Three Mile Island Nuclear Station Unit 1 (TMI-1)
Operating License No. DPR-50
Docket No. 50-289
Inadequate Core Cooling (II.F.2 NUREG 0737)

Attached please find revised pages to our July 6, 1984 (5211-84-2173) (SDD 662C Div II) submittal on the Reactor Inventory Trending System and a revised schedule consistent with our NUREG 0737 status response of October 3, 1984 (5211-84-2244). Amended responses to NRC Request for Additional Information dated June 14, 1983 and GPUN response of January 31, 1984 and July 6, 1984 is planned for submittal in March, 1985.

Revised pages to SDD662C Div. II

RCS Inventory Trending System

Figure 5. RC HOT LEG & RV HEAD LEVELS HISTORICAL DATA TREND DISPLAY

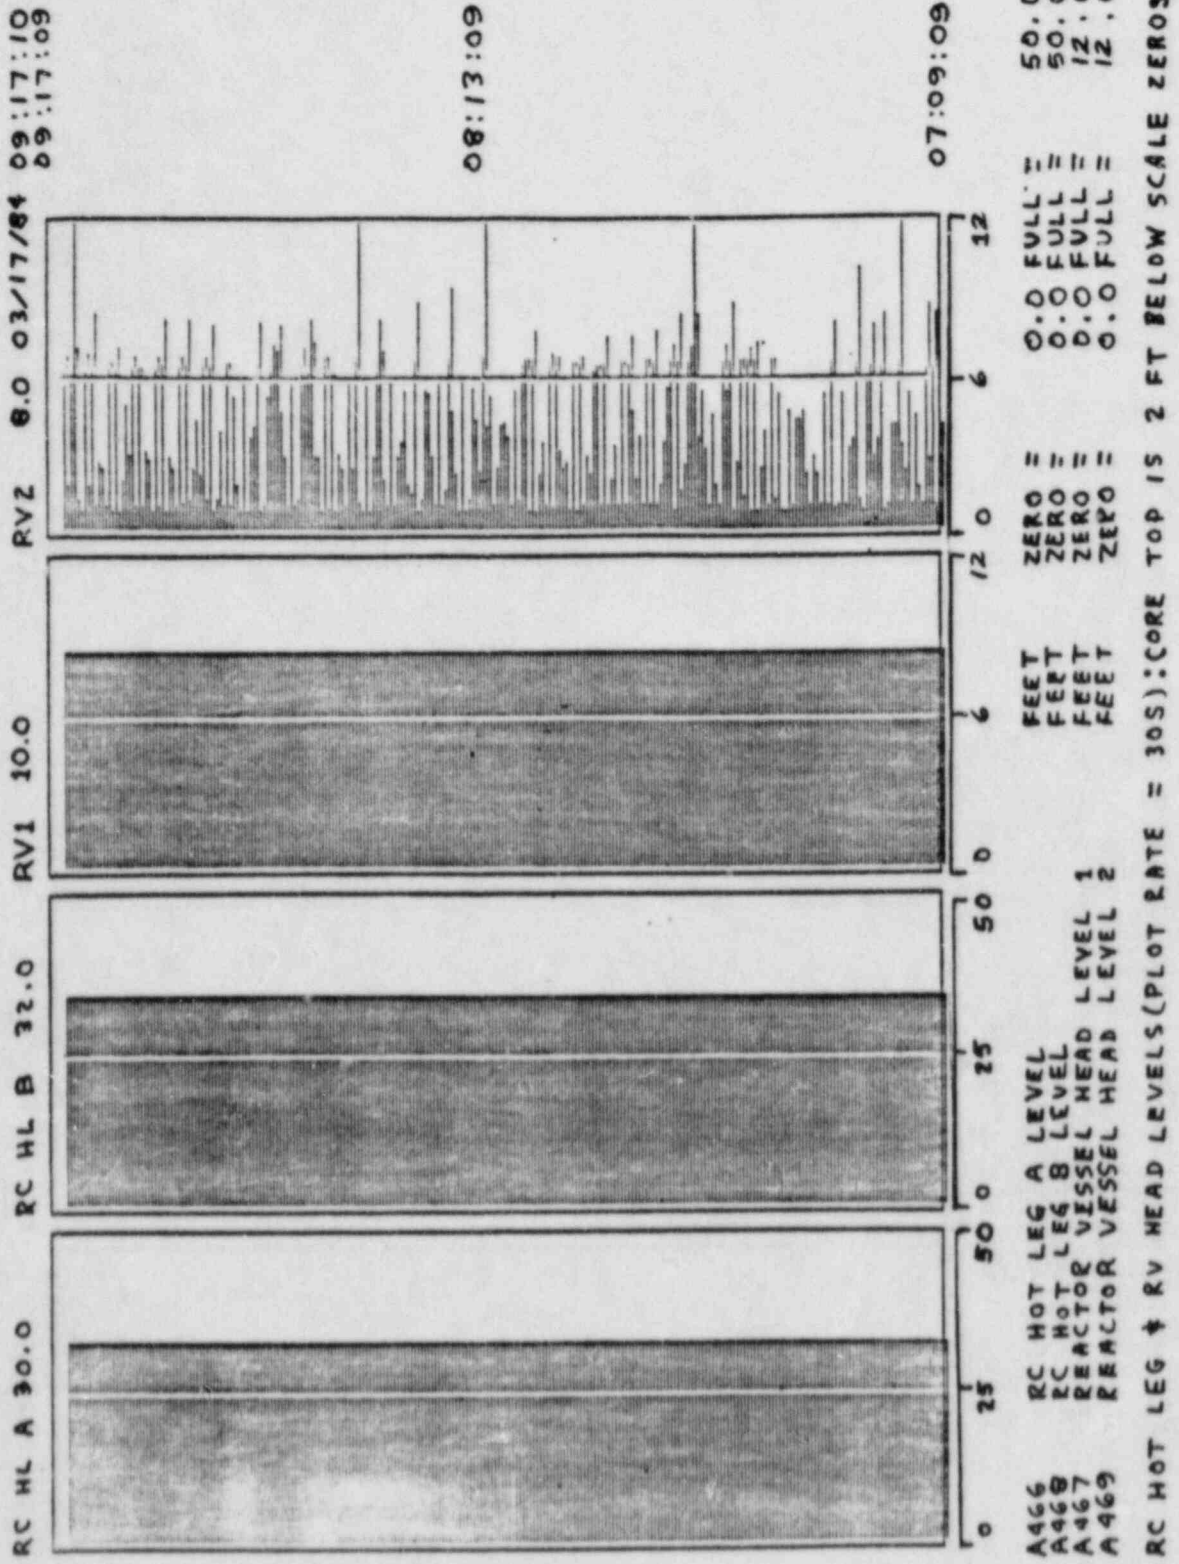
For variables A1 and A2, zero and full scale values are 0 and 50 feet, respectively. For variables A3 and A4, zero and full scale values are 0 and 12 feet, respectively. For variables B1-B4, zero and full scale values are, respectively, 0 and 100 percent.

Running lengthways down the middle of each rectangular box is a line the same color as the box which is the half-scale indication for each box.

The "meaningfulness" of both Group A and Group B data will be indicated on the historical data trend display. When either Group A or Group B data is not meaningful, a series of dots extending from the left-hand side of the box to the right-hand side will be displayed. The dots will be blue in color. The dots will be spaced apart in the horizontal direction the width of one character position. In the vertical (time axis) direction, the dots will be spaced apart the height of one character position. Also, the value at the top of a box will be replaced by a series of dots when the box's variable is currently not meaningful. An example which illustrates a case where historical data for the most recent hour was not meaningful is shown by the left-most box of Figure 6.
